January 14, 2022

RE: J&J Stone Pit #1 Permit No. M-2011-004 TR-2
Response to Second Adequacy Review Dated January 11, 2022

4MILE SANDSTONE QUARRY BLASTING PLAN

Figure 2: Structures within a 1/2 mile radius of Blast Point

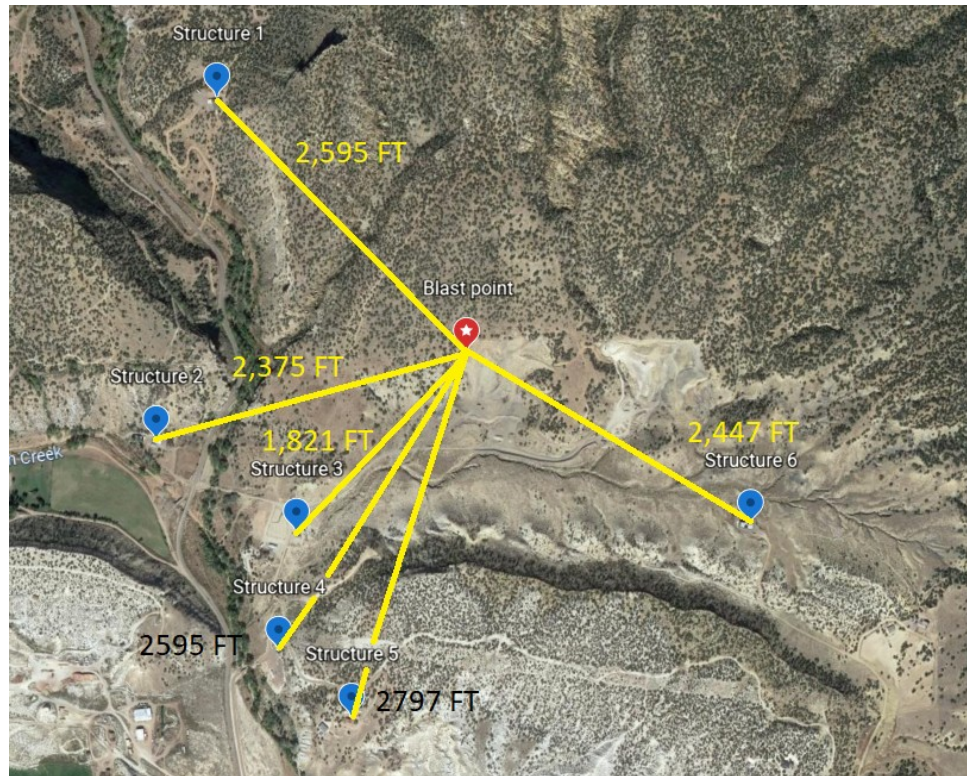
Item B. Pre-Blast Survey: The pre-blast survey extent includes the structures identified by the Division and discussions to date with the structure owner.

- b. Google imagery reveals five structures and wells, within approximate one-half mile radius, to the west. These locations are noted on Figure 2 Blast Point below. The following listed properties will be site inspected and surveyed, to document any pre-existing conditions or damages before any blasting is conducted at 4Mile Quarry. Current Google imagery shows these five locations at or less than one half mile from the blast point; however, the blast point is speculative and must be determined prior to each blast. Blasting is likely to move in a westerly direction in the future. This would extend the distance from the five locations and place some of the locations outside of one half mile. Prior to blasting, the GPS coordinates of the shot will be compared to existing structures within a one half radius and those identified will require an inspection and survey to be included in a pre-blast analysis. This analysis should be documented and included in the blast report. All of the owners of these residences, properties, wells, and other structures have been contacted and notified of the use of explosives on this site. 4Mile Quarry operates under the belief that the surrounding land owners and neighbors are stakeholders in our success. The quarry manager has maintained an open line of communication about all aspects of operation, to include blasting. Below is a description of current structure conditions obtained during previous pre-blast surveys and communications with the owner of the structure.

Structure #1 - William Mosher residence and well is 2,595' from blast point (45' inside the outside radius). The quarry manager and production manager have both talked numerous times with Mr. Mosher about operations at Fourmile. Previous blasts have placed his property outside the blast point. To initiate a pre-blast survey, however, any future blasts will require a documented pre-blast survey to be included with the blast report. There have been no complaints or issues reported by Mr. Mosher and the use of explosives to date.

Structure #2 - D.J. Yeoman residence and well. 2,375' from blast point (265' inside the outside radius). The quarry manager has had numerous conversations with the owner about the operations. Mr. Yeoman has a detached garage and carport and lives in an RV at this location. Previous blasts have placed this location outside of the distance to require a pre-blast survey. Any future blasts however, will require a documented pre-blast survey to be included in the blast report. Mr. Yeoman has made no complaints or had any issues with the use of explosives to date.

Structure #3 - 4Mile Inc. owns the structures and well at this location. Mike and Jason Krauth, owners of this company, are the permit holders and have never had any damage to structures or well as a result of the use of explosives, to date.

Structure #4 - Stewart Phelps carport and boxcar. These uninhabited structures are portable storage structures. 2595' from blast point (45' inside the outside radius). Mr. Phelps is familiar with operations at Fourmile. Previous blasts have placed this location outside of the pre-blast survey. Any future blasts however, will require documented pre-blast survey to be included in the blast report. Mr. Phelps has had no issues or

complaints regarding use of explosives to date.

Structure #5 - Stewart Phelps residence and well. 2797' from blast point (157' outside the outer radius). Mr. Phelps has not been included in any pre-blast survey but is familiar with operations at Fourmile. Any future blasts will require a documented pre-blast survey to be included in the blast report. Mr. Phelps has had no issues or complaints regarding use of explosives to date.

Structure #6 - John Waters residence and well. 2447' from blast point (193' inside the outside radius). Mr. Waters is familiar with operations at Fourmile. The quarry manager was made aware by Mr. Waters of several settling issues resulting in structural cracking several years ago and prior to any use of explosives. Mr. Waters has mitigated the damage and repairs with engineers and it includes ongoing monitoring, and ongoing repairs. The quarry manager has visually inspected the damage and been made aware of these issues. The quarry manager considers Structure #6 as the most sensitive to issues concerning the use of explosives. The quarry manager monitors the conditions and keeps the owners informed of operations at Fourmile. A pre-blast survey will be conducted at this location and documented and included with the blast report. Mr. Waters has reported to the quarry manager, that the noise and vibration have been loud on one occasion at which time I visited the residence. I did not observe any damage and none has ever been reported by Mr. Waters. I have since required any explosives professionals conducting blasting operations at 4Mile Quarry to use additional delays in patterns to reduce noise. No complaints of damage to property from the use of explosives have ever been made or reported. No structures or contents were identified as sensitive to blasting.
